Clio II Scénic

Laguna Espace

LOCKING TOOL TIGHTENING TORQUE SPECIFICATION FOR CAMSHAFT PULLEYS Mot. 1509
AND Mot. 1509-01

- Engine: F4P - F4R
- Gearbox: XXX

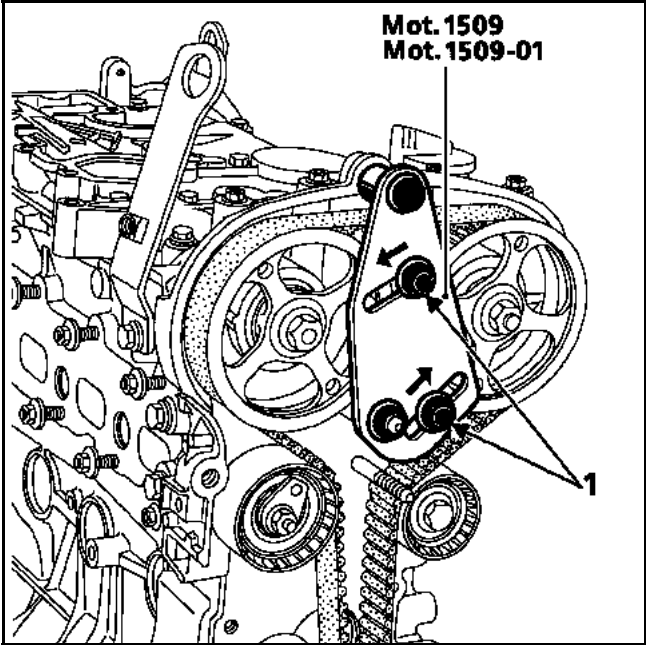
When fitting **Mot. 1509** and **Mot. 1509-01** (F4R engine), the gear wheels of **Mot. 1509** should be brought into contact with the camshaft pulleys, and the nuts (1) tightened to a torque of **8 daN.m**.

This will avoid the **Mot. 1509** gear wheels slipping onto the camshaft pulleys during removal-refitting.
